Model: Specific Evora 400
'18 Model Year VIN's

Number: 2019/01
Federal Market

Replacement of the rear tail lamps due to the possibility of incorrect illumination during the combined turn indicator and brake light operation.

Lamp Identification

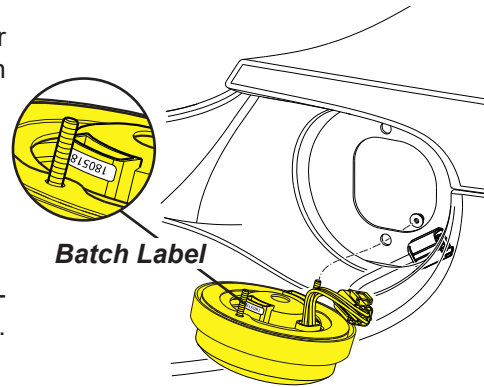
With the lamp(s) removed from the vehicle, the batch date label is adhered to the lamp housing, positioned opposite to the part number label.
